BOARD OF COMMISSIONERS OF THE PORT OF NEW ORLEANS
NOTE TO PERSPECTIVE BIDDERS
CONTRACT FOR
FRANCE ROAD TERMINAL AND JOURDAN ROAD
REPAIRS TO PUMP STATIONS P2-P5 AND
PATTERSON PUMP STATION
DAMAGE BY HURRICANES KATRINA AND GUSTAV

August 1, 2011

ADDENDUM NO. 3

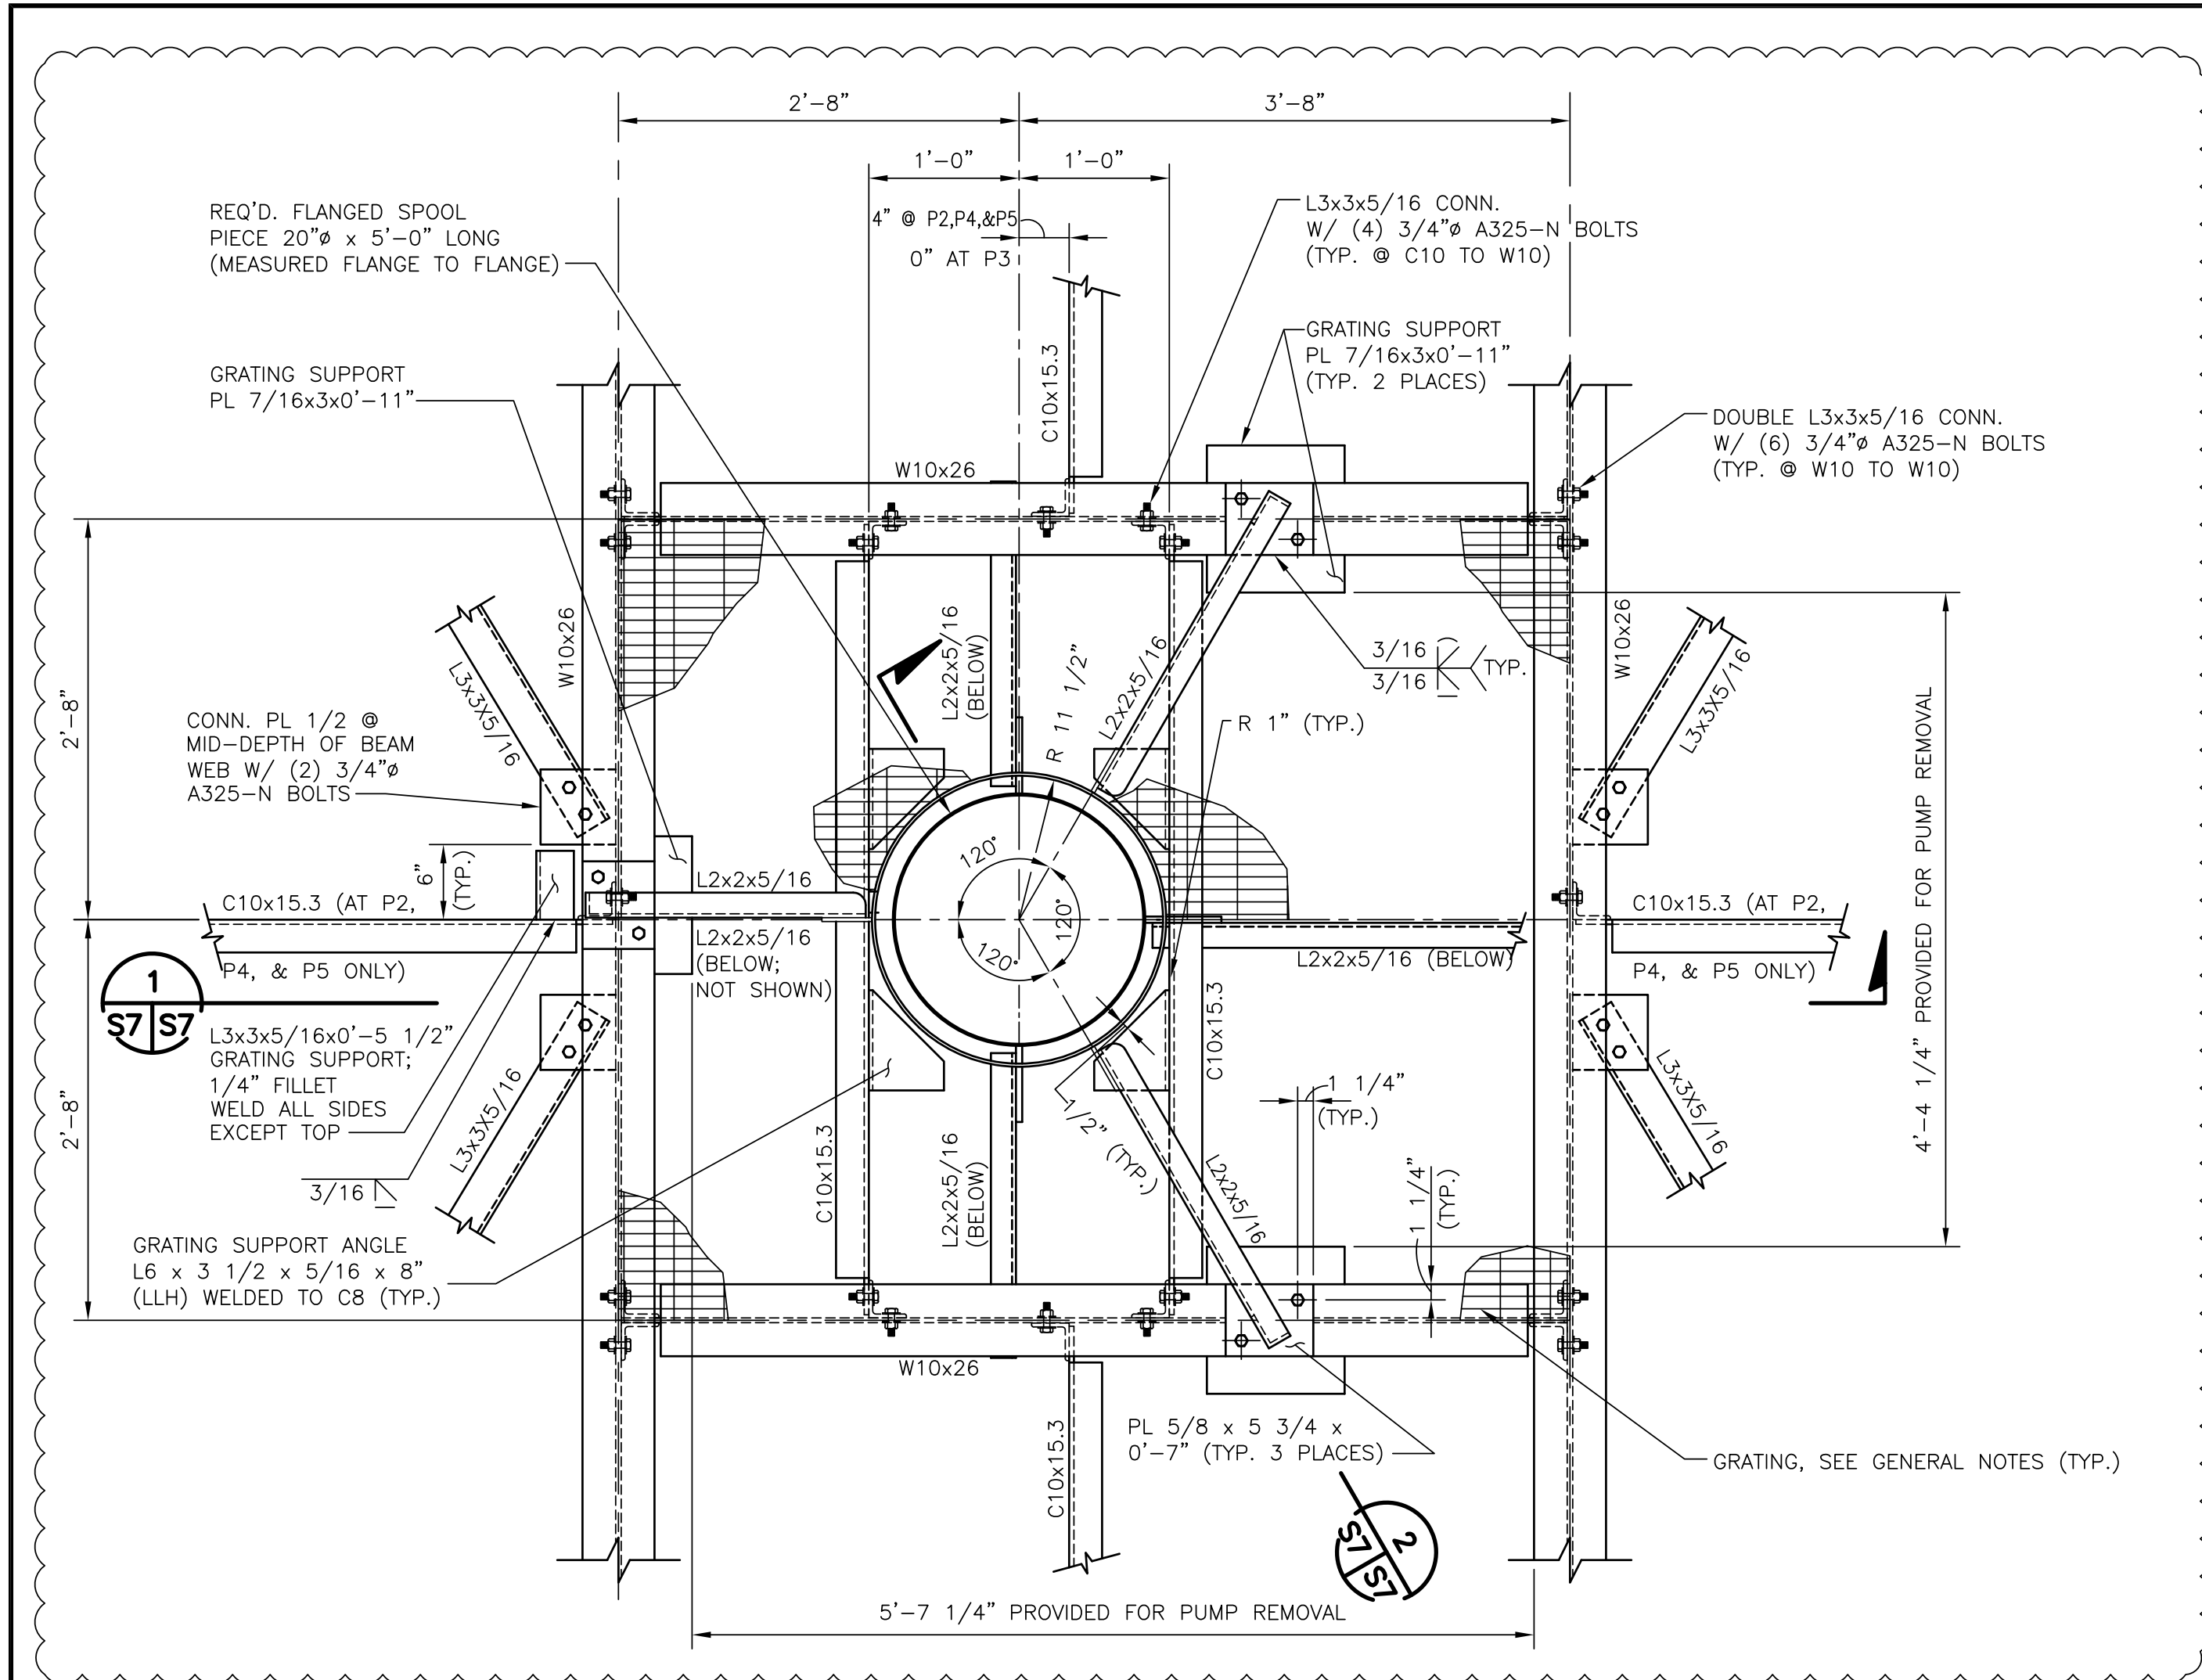
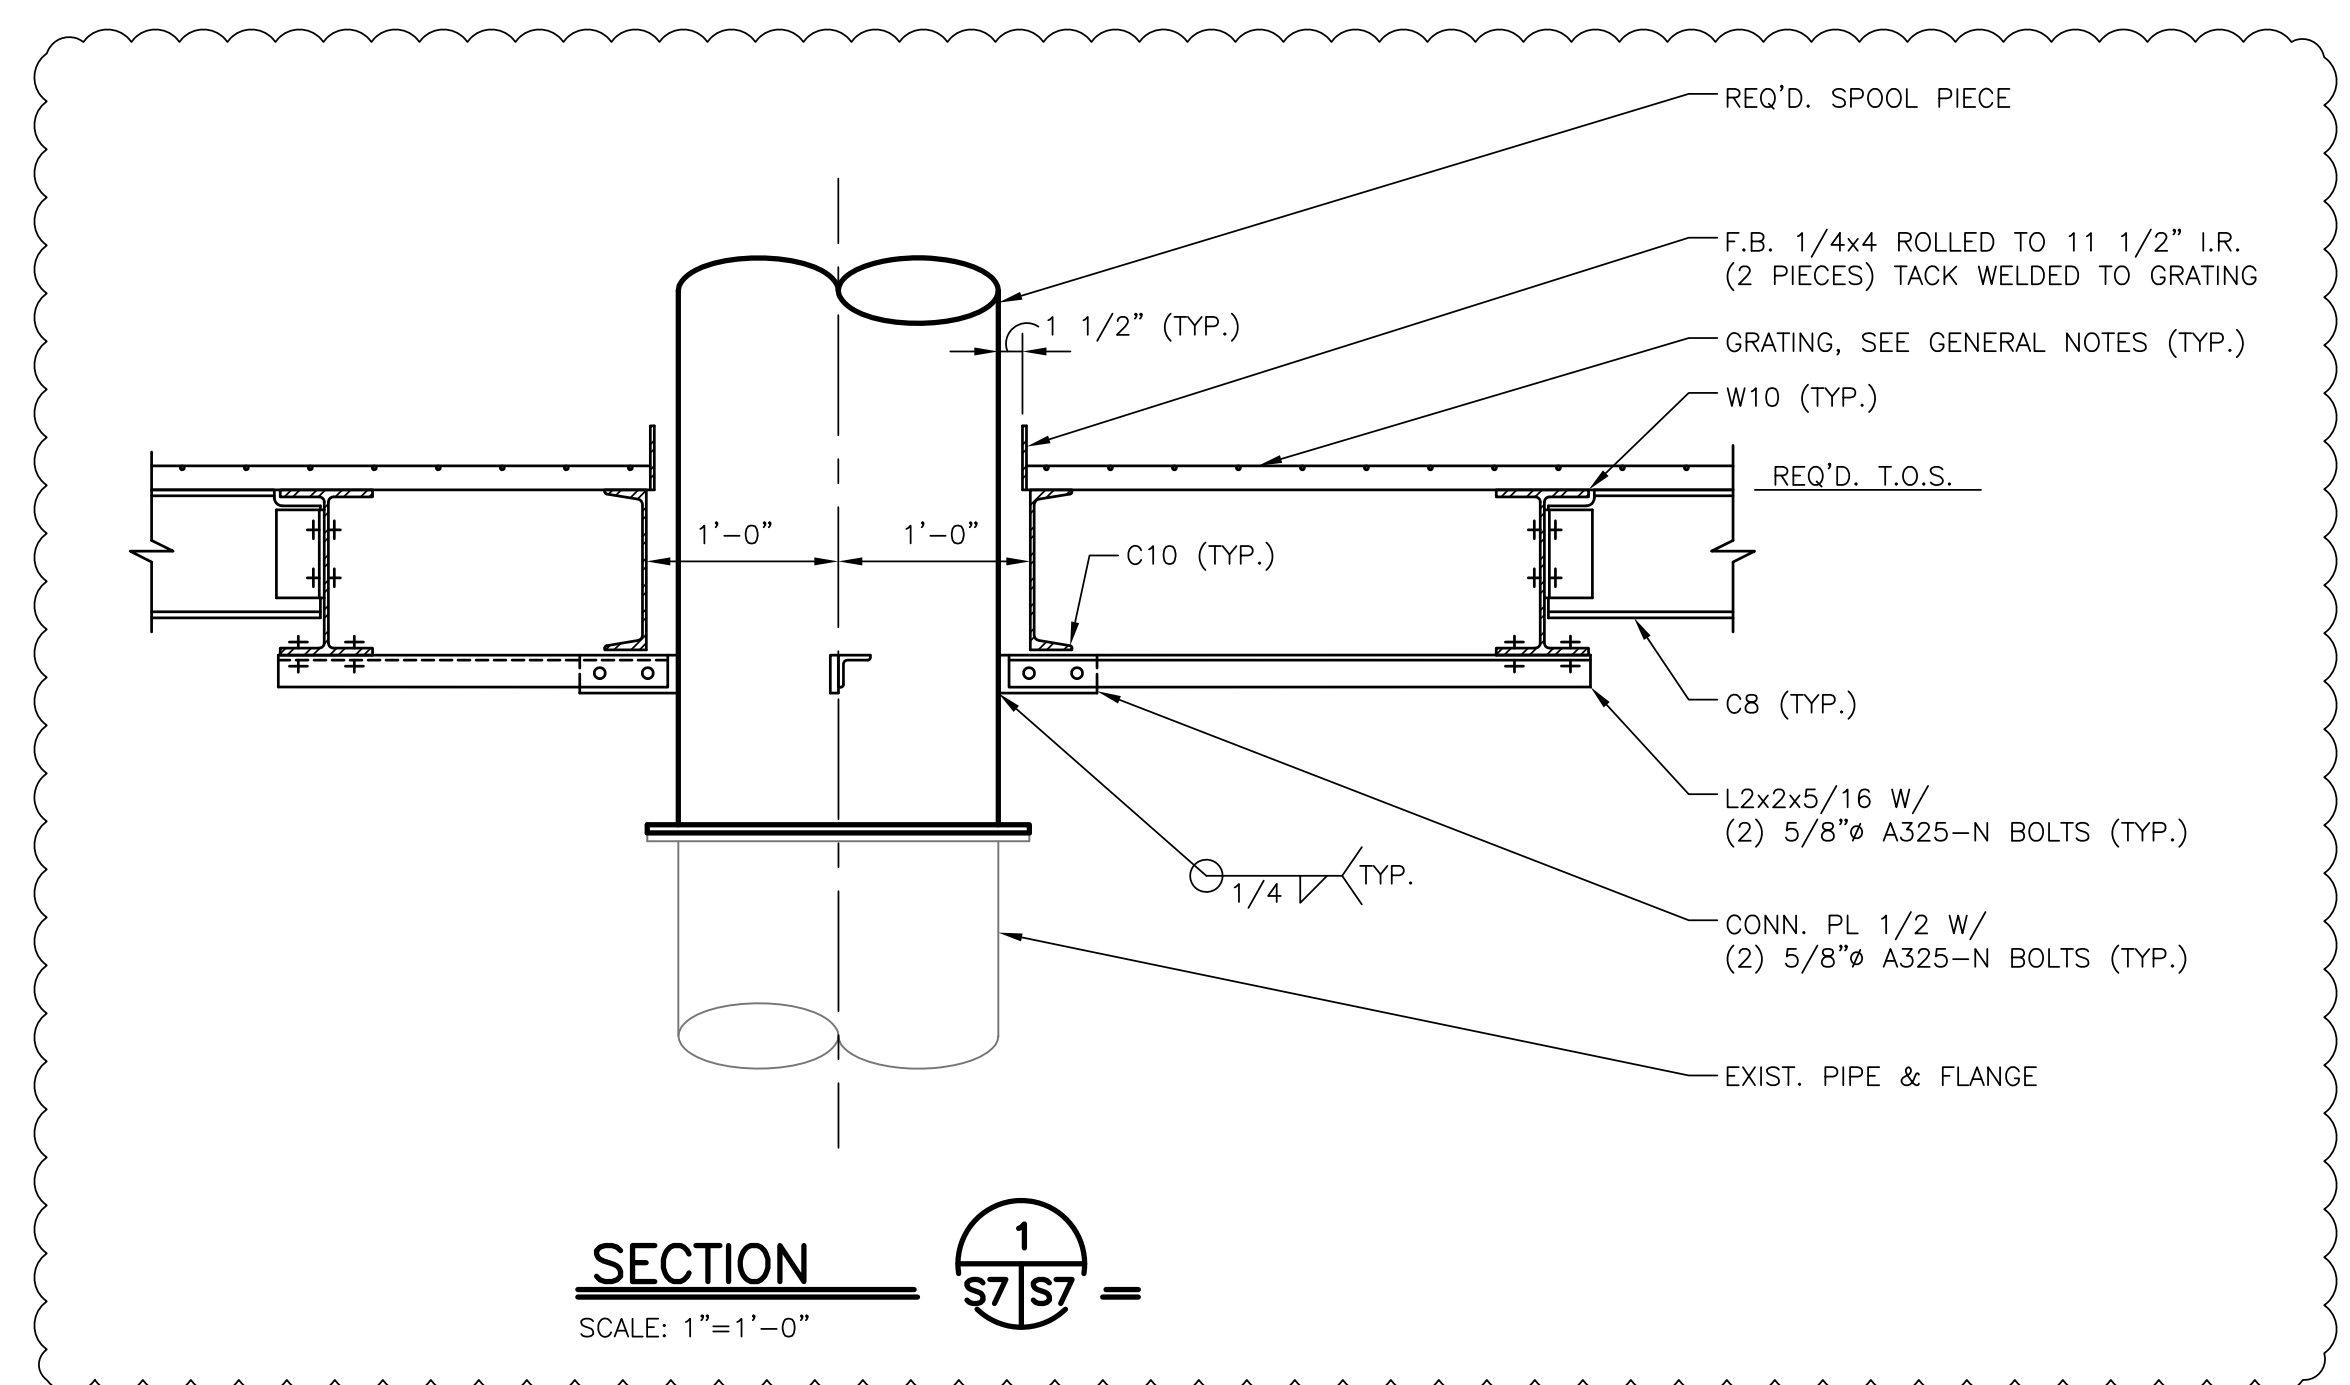
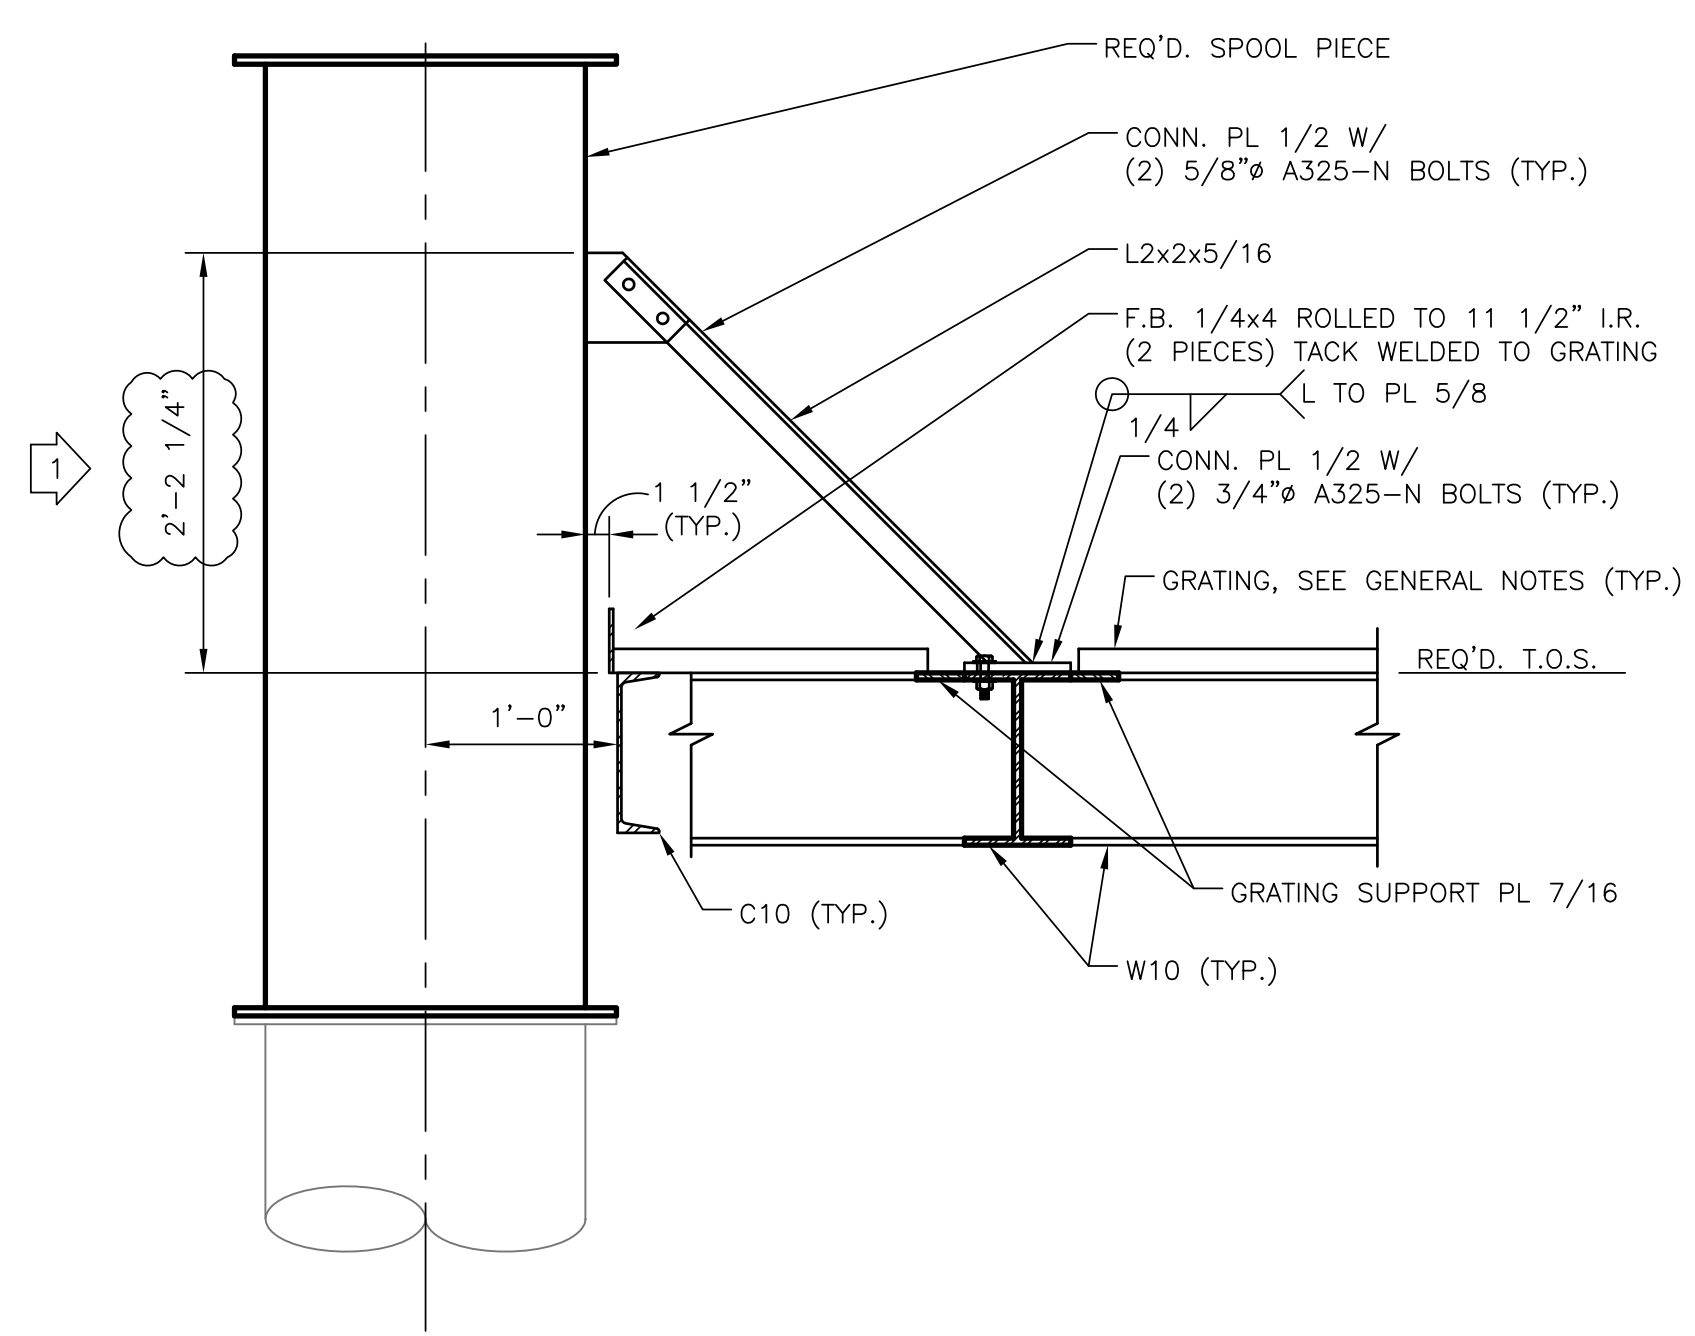
Q7: Plan Sheet S-7 shows 3 - 2x2x5/16 angle iron braces from the new High Ring Bases down to the structural steel platform members and four 4 - 2x2x5/16 angles horizontally connecting the High Ring Base to the steel platform members. As we see this installation, any vibration from the Pump will be directly transmitted to the platform. It also appears that the High Ring base could possibly be supporting a portion of the steel platform. Shouldn't the Pump, High Ring Base and Motor be kept separate from the platform around it?

ADDENDUM NO. 3
REVISED GRATING OPENING AND ROTATED
EXISTING PUMP & DISCHARGE PIPE
DATE 08/01/2011

Answer: The steel platform shall remain as shown on and as specified in the Bid Documents.
